**Report on Consultation – Route Options**  
**Bhlaraidh Extension Wind Farm Grid**  
**Connection**  
**January 2021**

**REF: LT295**

**Plate 3.1: Preferred Route**

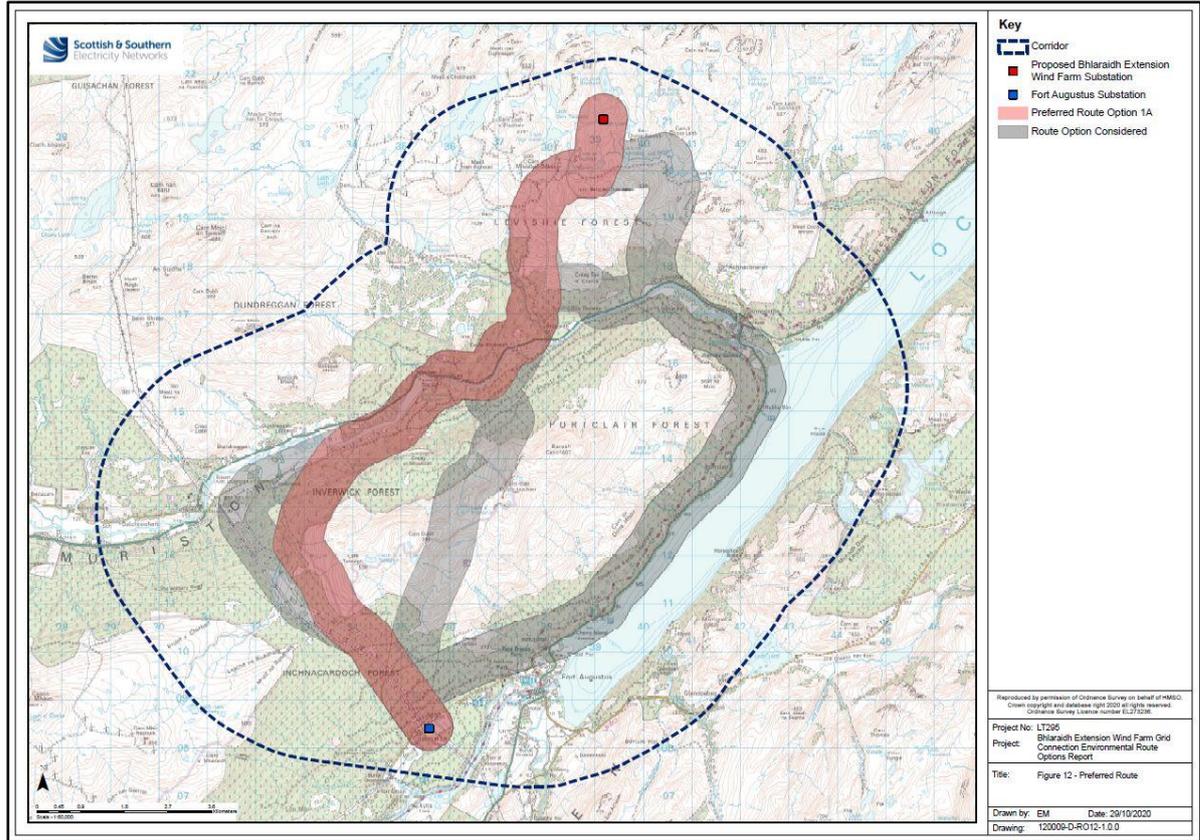
Historic Environment Scotland (HES)	<p>We are content with the selection of Route Option 1A as the preferred route for the overhead line. While we note that this route is located in the vicinity of heritage assets such as the category A listed Torgoyle Bridge (LB14996), we are content that impacts will not be significant.</p>	<p>Noted.</p>
	<p>We have identified some issues with the other route options under consideration. In particular, route options 2 and 2A have the potential to affect the Cherry Island, Crannog, Inchnacardoch Bay, Loch Ness Scheduled Monument (Index no. 9762) and its setting. Route Option 2A overlaps with this scheduled monument and there may be some potential for direct impacts. Additionally, route options 2 and 2A may give rise to impacts on the setting of the Category A listed Invermoriston, Home Farm and Former Barn to Rear (LB15021) caused by the appearance of overhead line infrastructure in westward views towards the building across Loch Ness.</p>	<p>The concerns in relation to route options 2 and 2A are noted. These two route options were identified as having numerous environmental and engineering constraints to development early in the options assessment, with Route Option 2A being the least preferred of all options. Alignments within route options 2 and 2A will not be explored for this development.</p>

Stakeholder	Summary of Feedback	Response by SHE Transmission
Forestry and Land Scotland (FLS)	<p>FLS are keen to support SSE projects and work in partnership, while facing challenges on a range of objectives. The following points are key for achieving this balance:</p> <ul style="list-style-type: none"> <li>• The current line is underground from the quarry to the dam (part of Route Option 1), and we would prefer the same approach to be adopted for this project.</li> <li>• Route Option 1A would cut through a core Caledonian pine wood remnant.</li> <li>• Route Option 2, it is understood, has been discounted.</li> <li>• Route Option 3 would have a highly significant landscape and environmental impact in a highly visible area where we are working to restore and expand native woodland habitat. This includes a nationally important Caledonian pinewood remnant that currently has wayleaves on two sides.</li> <li>• Route Option 3 would also introduce a new set of operational constraints for our activities and would result in avoidable deforestation.</li> <li>• Route Option 1 - the use of existing wayleaves offers a range of benefits: <ul style="list-style-type: none"> <li>○ Limited additional visual impact with the impact being concentrated in the existing wirescape;</li> <li>○ No further impact on native woodland habitat;</li> <li>○ No additional operational constraints; and</li> <li>○ No further deforestation.</li> </ul> </li> </ul> <p>In light of the above points, we do not support route options 1A or 3 as options and see the use of existing wayleaves in Route Option 1 as a pragmatic solution that minimises impact across a wide range of issues.</p>	<p>SHE Transmission are committed to working closely with FLS, and note the key points raised.</p> <p>SSE would clarify that use of Route Option 1 would still require tree felling, as the current wayleaves would require expansion to accommodate the new overhead line. This would result in removal of native woodland and core Caledonian pine wood areas. Consequently, Route Option 1A was determined to be preferable over Route Option 1 in forestry terms, as there appears to be greater opportunity to avoid Caledonian pine wood and reduce the length of native woodland the overhead line would pass through.</p> <p>Further consultation is being undertaken with FLS. In recognition of the points raised by FLS, it is proposed that Route Option 1 is carried forward as a secondary option to ensure that the consideration of alignment options in both routes 1 and 1A be considered further during the alignment selection stage of the project. Both the preferred and secondary options are shown on <b>Figure 1</b>.</p>

- 7.1.3 To address these points, the following actions are being undertaken:
- Alignment options will be considered within the Preferred Route Option 1A, as well as the secondary Route Option 1. The preferred and secondary route options are shown on **Figure 1**; and
